Salem Generating Station Units 1 and 2
Facility Operating License Nos. DPR-70 And DPR-75
Docket Nos. 50-272 And 50-311

Subject: Response to Request for Additional Information
Request for License Amendment – Topical Report References in
Technical Specification 6.9.1.9, Core Operating Limits Report

PSEG Response to NRC Request For Additional Information Regarding
Request for Amendment to Salem Generating Station Unit 1 and 2 Technical
Specifications - Topical Report References in Technical Specification 6.9.1.9, Core
Operating Limits Report – *Non-Proprietary Version*

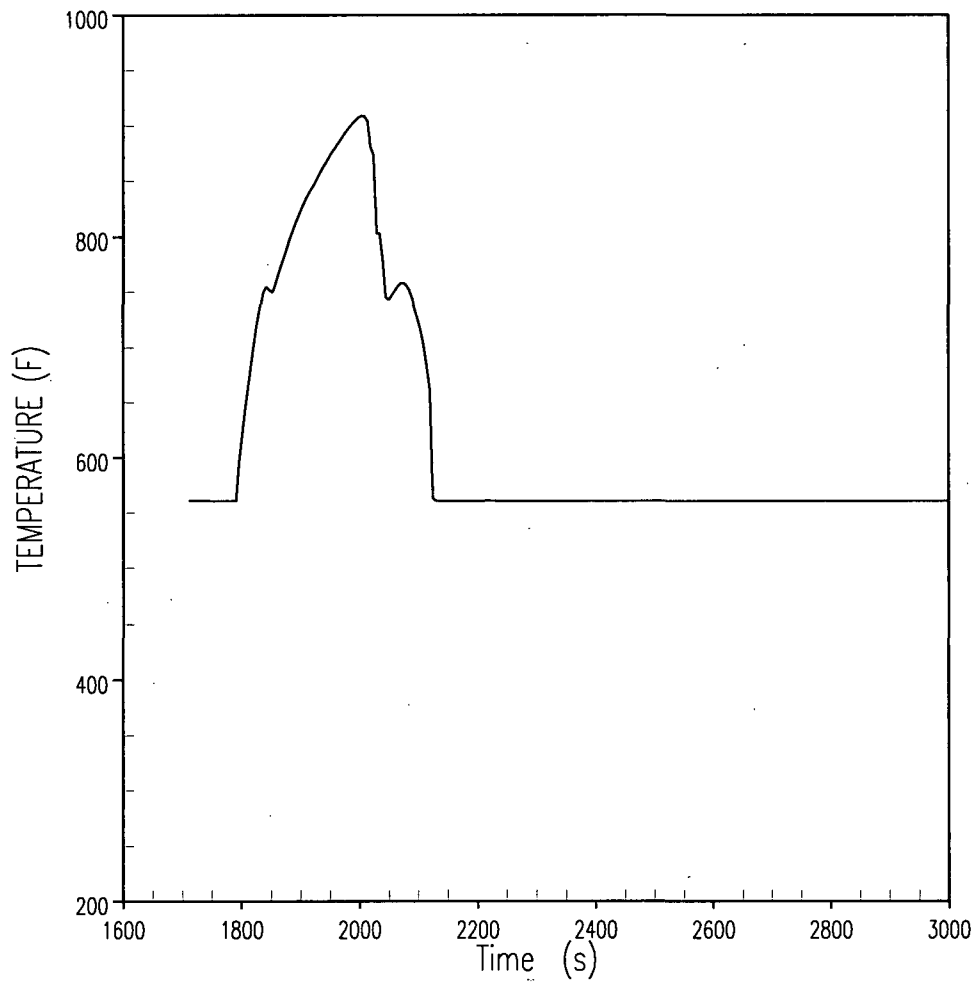
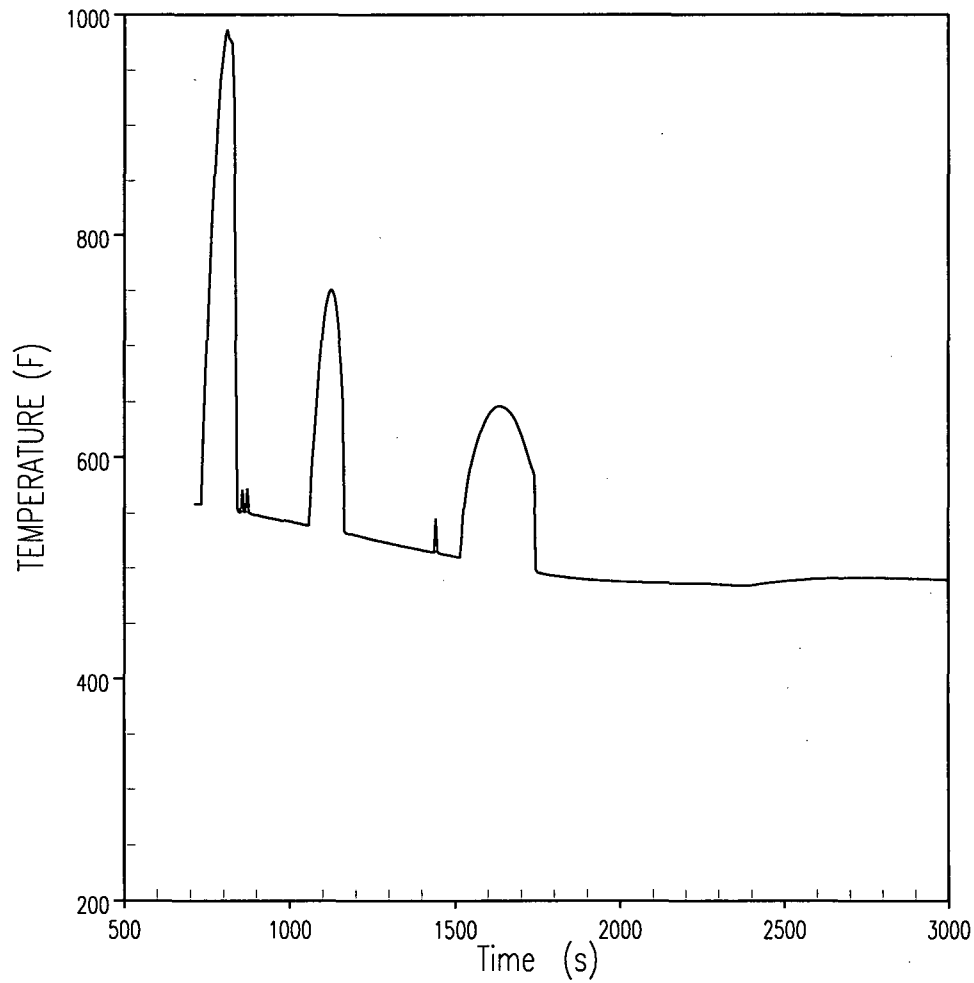
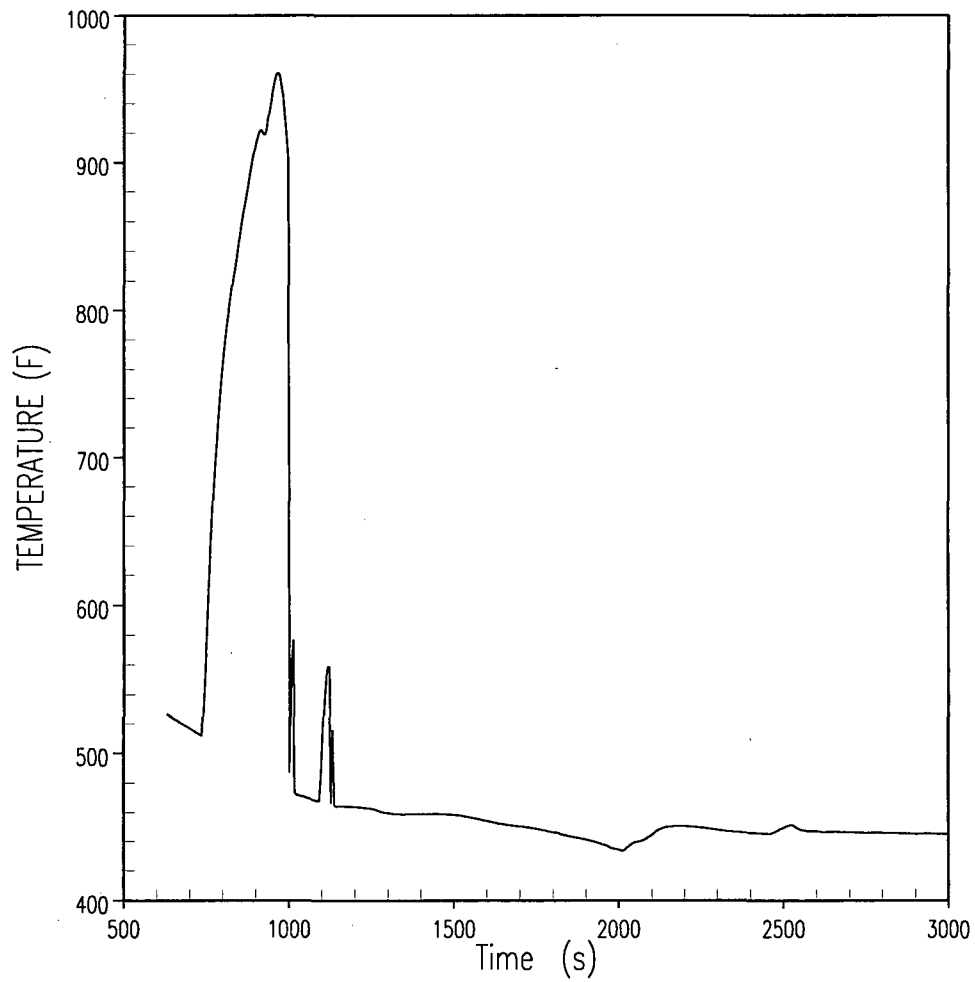
2. Section 4.2 of Attachment 1 to your submittal states that “the standard “integer” break spectrum was used...” Please identify the breaks that were calculated and the results (peak cladding temperature (PCT), O₂, H₂, and a PCT vs time plot) that were obtained for each analyzed break.

The break spectrum analyzed in support of PSEG’s September 26, 2006 amendment request is the same as the Salem Generating Station current licensing basis spectrum (i.e., 1.5, 2, 3, and 4-inch breaks). Table 2-1 below includes information for the peak cladding temperature (PCT), maximum local oxidation, and hydrogen generation for each of the break sizes analyzed. Figures 2-1 through 2-3 include the PCT versus time plots for each of the applicable break sizes. Note that as a result of SBLOCA analysis submittals for various Extended Power Uprate (EPU) and RSG programs, the NRC recently challenged Westinghouse on the coarseness of the standard NOTRUMP-EM break spectrum (i.e., 1.5, 2, 3 and 4 inch) (e.g., Callaway Unit 1 Amendment No. 168, dated September 29, 2005, TAC No. MC4437 (ML#052570054)). The Westinghouse position on the NOTRUMP-EM break spectrum was sent to the NRC in Reference 1 and included a proposed approach for future NOTRUMP-EM analyses. In any future applications of the NOTRUMP-EM, if any integer break size PCT is approximately equal to or greater than 1700°F, or if the PCT results are close to or greater than the corresponding Large Break LOCA (LBLOCA) PCT results, the analysis includes a refined break spectrum to assure 10 CFR 50.46 compliance. The results presented herein do not show PCTs approximately equal to or greater than 1700°F. Also, enough margin exists between the SBLOCA PCT and the LBLOCA PCT (2038°F, Reference 2) to justify not including a refined break spectrum in this analysis.

Result	1.5-inch (1)	2-inch	3-inch	4-inch
PCT (°F)	N/A	910	987	964
Maximum local oxidation (%)		0.00	0.01	0.01
Total hydrogen generation (2)		<1%	<1%	<1%
